Application for Resource Consent - Proposed Bach Extension For Mr & Mrs Stevens, Tara Bay, Kenepuru Sound
Project S2002-522h, RC No: U021320

PROJECT	Mr & Mrs Stevens Bach Extension, Tara Bay.		
PROJECT No.	S2002-522		
TITLE	DRAINAGE FIELD SPECIFICATION		DRAWING No. C.12.0
DRAWN MJH	CHECKED	SCALE NTS	DATE 11/02
COMPUTER FILE: MASTER\2002\STEVENS			REVISION A

SITE & DRAINAGE PLAN

Receipt of application for resource consent - U021320 - Stevens, Alex - Tara Bay Kenepuru Sound

DRAINAGE / SITE PLAN

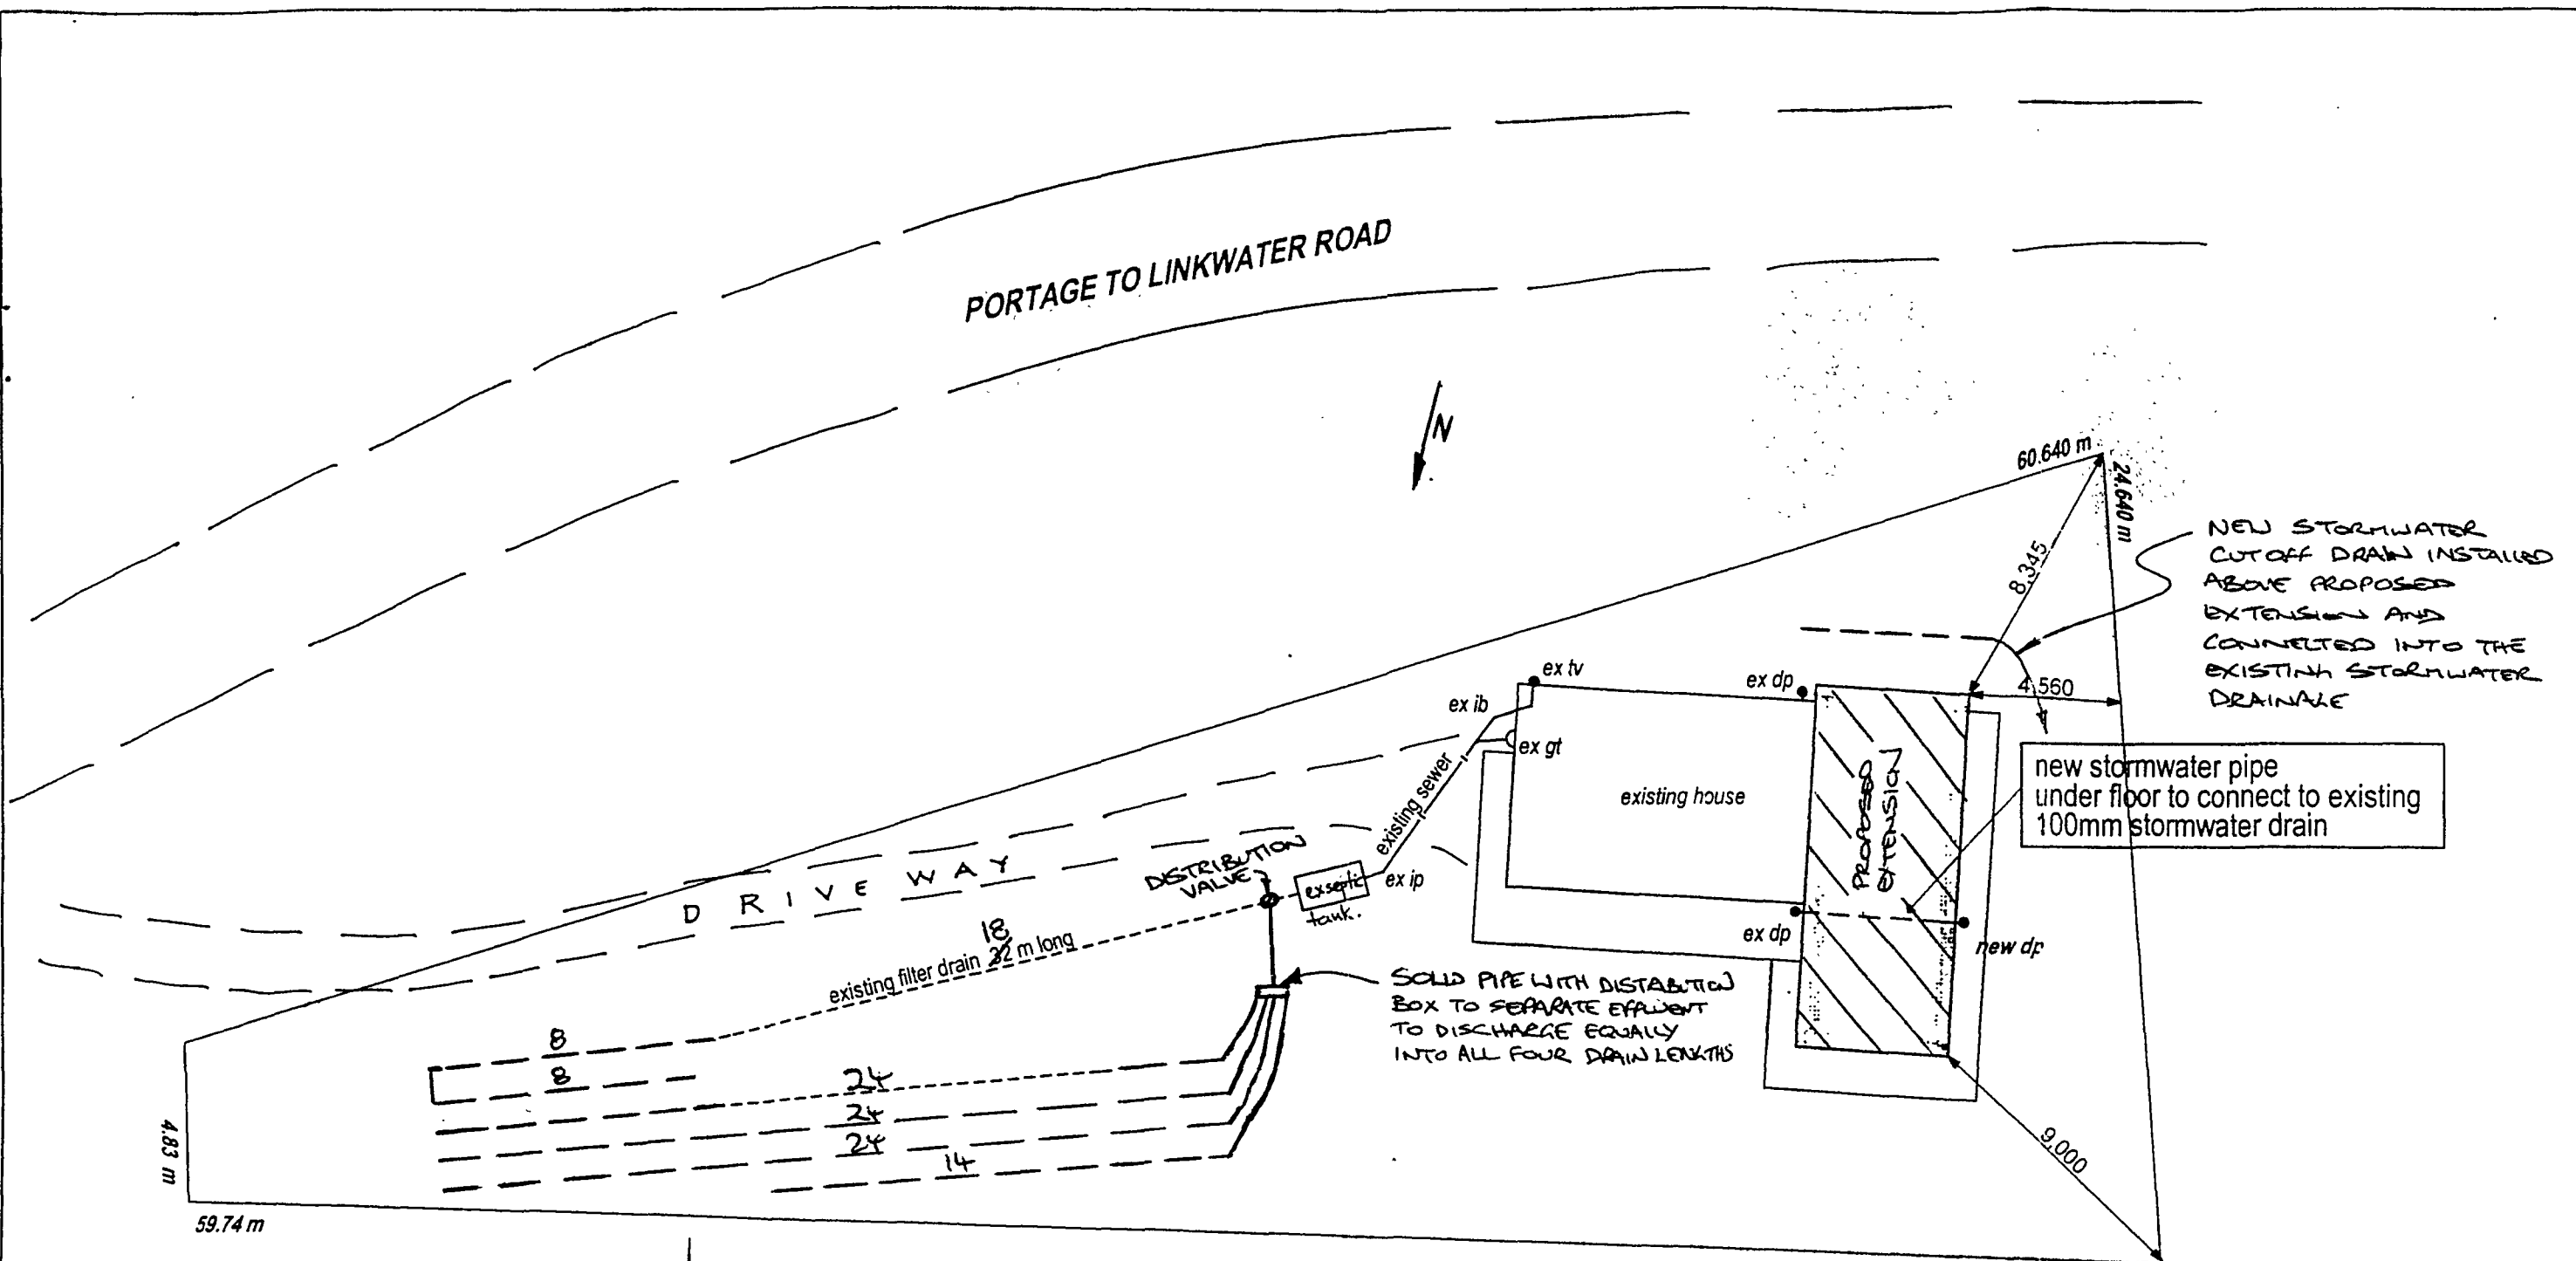
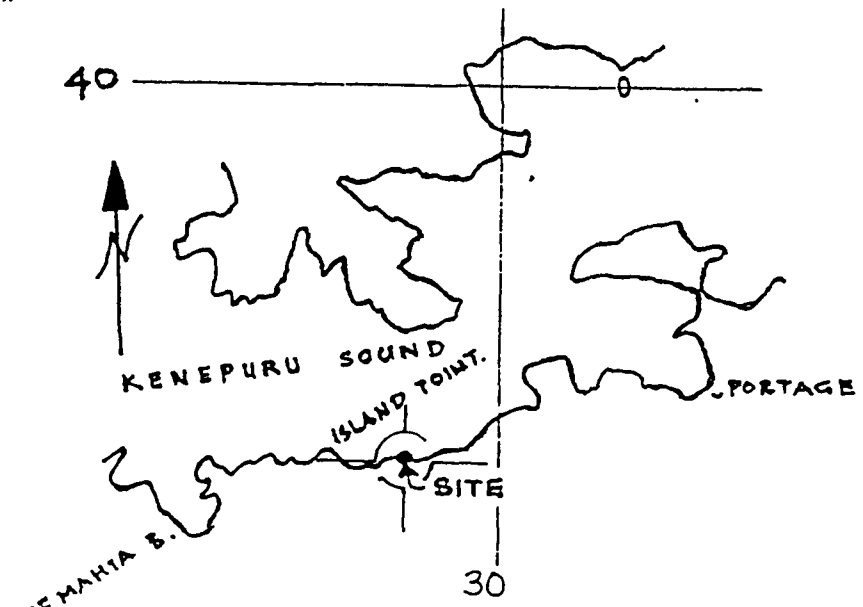
Further to our telephone conversation today please find attached our revised wastewater disposal layout.

As discussed, the layout now includes a distribution valve to allow some of the trenching to be rested, and a distribution box on the lower section to enable the four lines to be dosed equally; in accordance with NZS 1547:2000.

SOLID PIPE WITH DISTRIBUTION BOX TO SEPARATE EFFLUENT TO DISCHARGE EQUALLY INTO ALL FOUR DRAIN LENGTHS

DRAINAGE / SITE PLAN
1:200

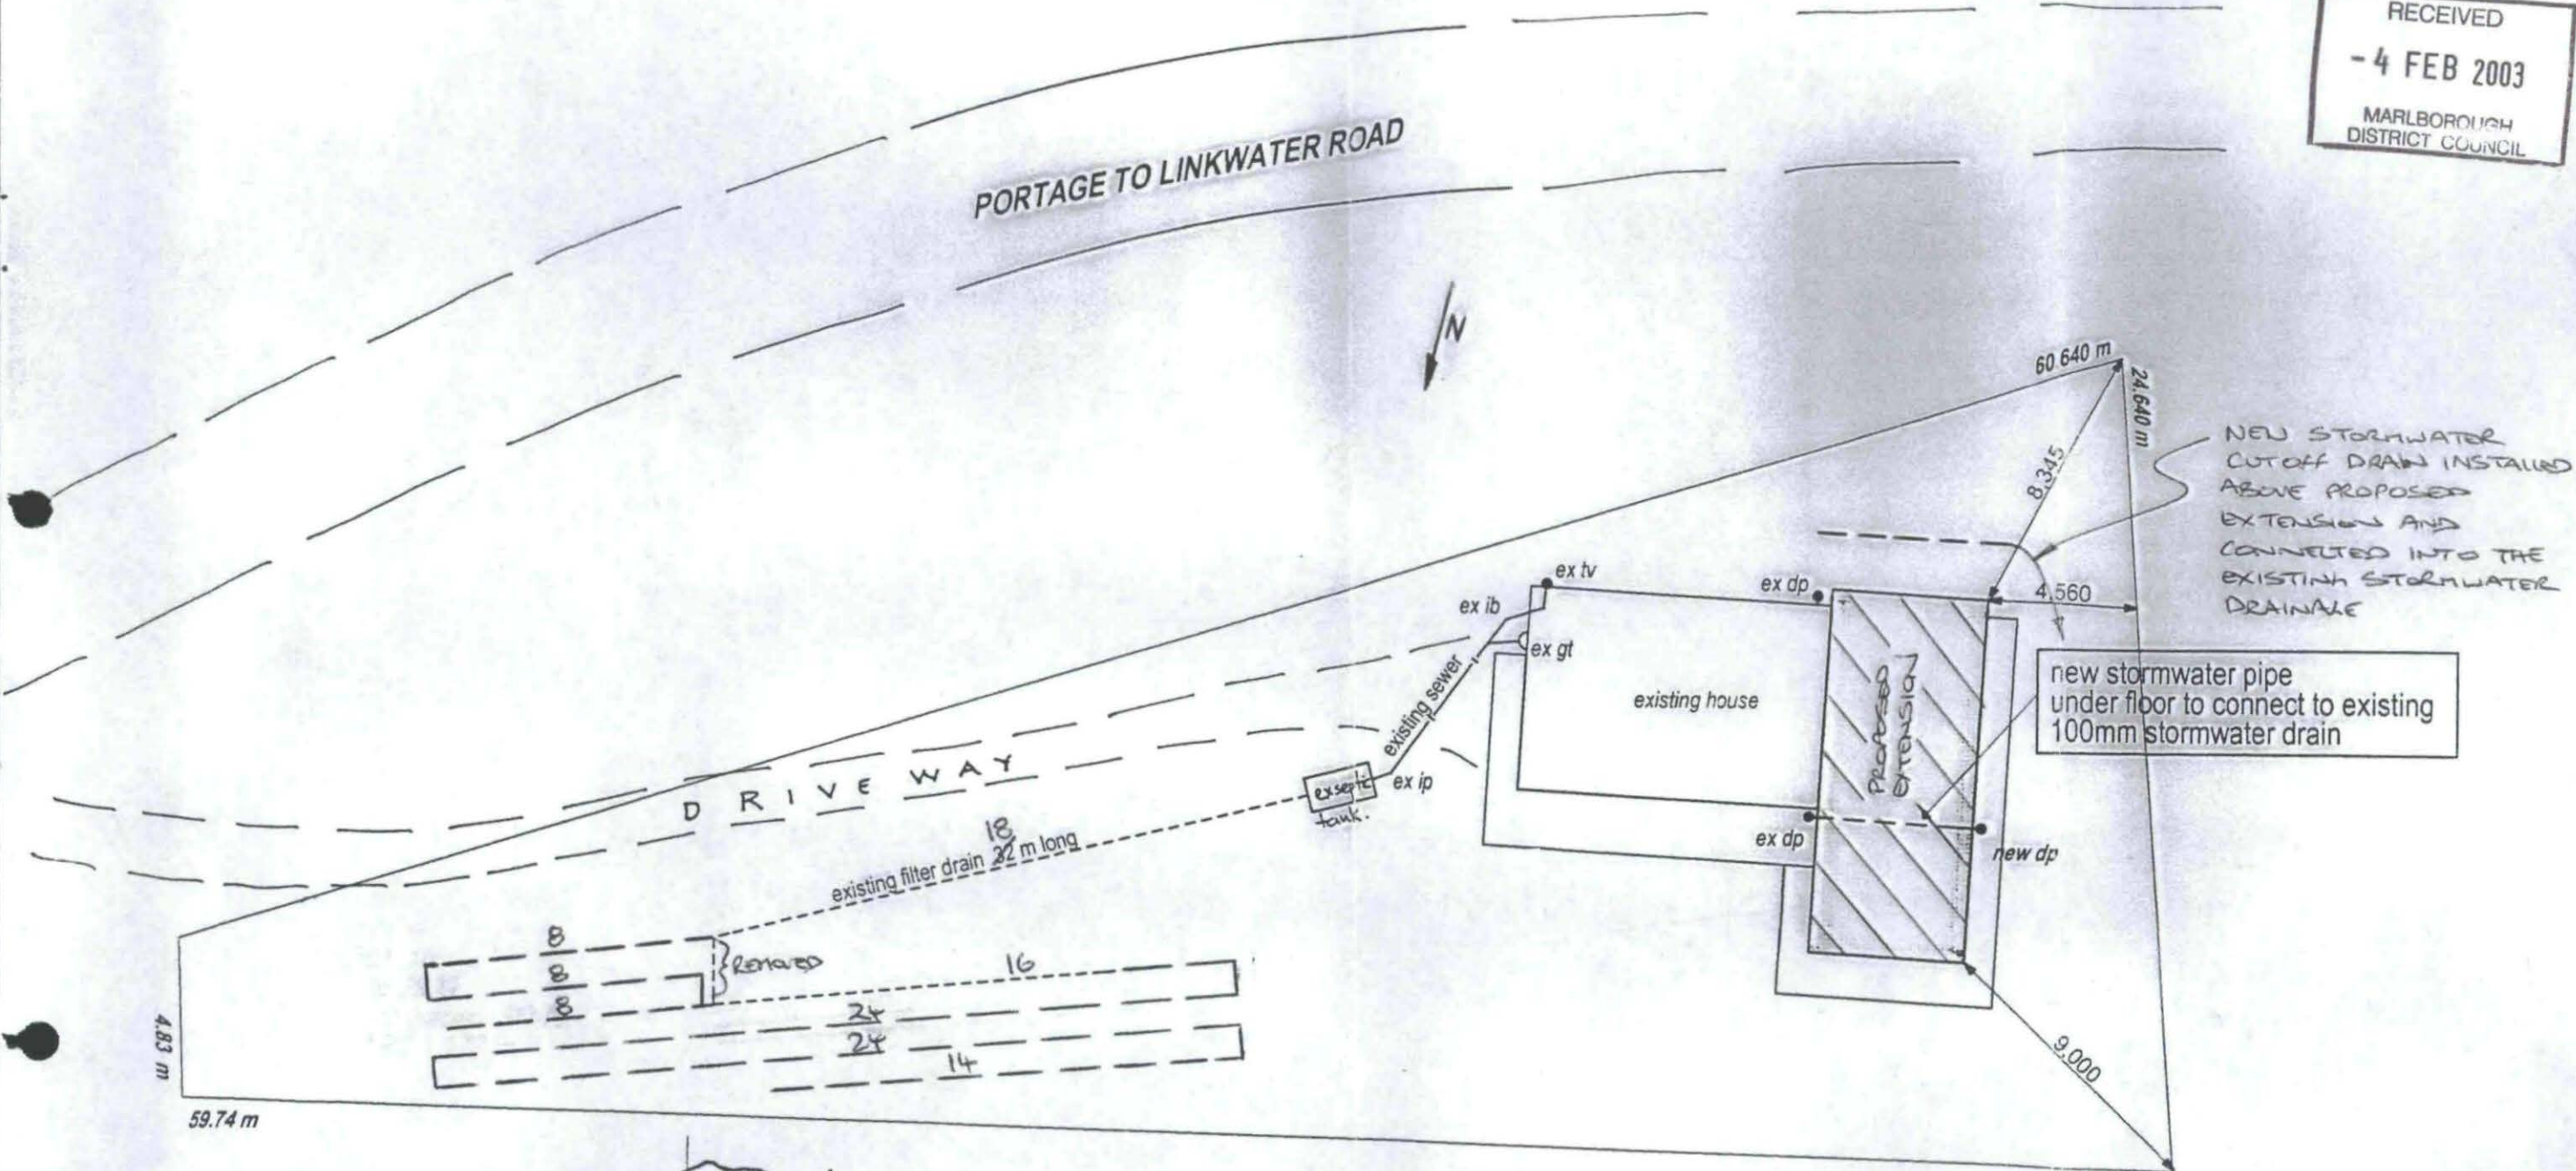
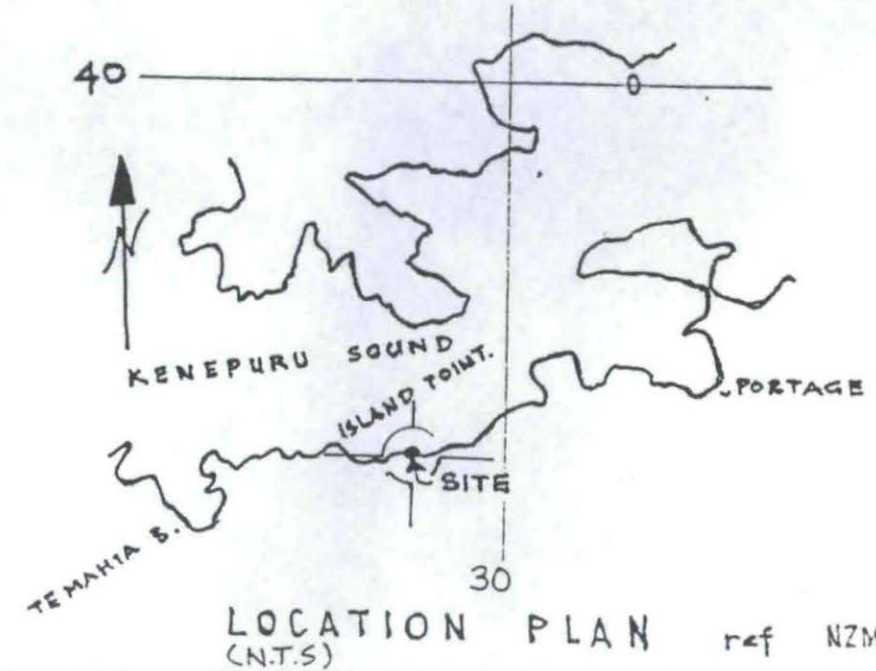
1. Our client has confirmed that the existing septic tank at the above site holds in excess of 3000 litres.
2. Please find attached our revised Professional Opinion which now also covers the effluent disposal, as requested.
3. We now have more information regarding the setting out of the drainage trenches and, in order to be able to better follow the contours of the land and avoid the removal of several mature Manuka trees, the proposed drainage layout has been revised as shown on the attached site plan. The revised layout shows 120m of trench.
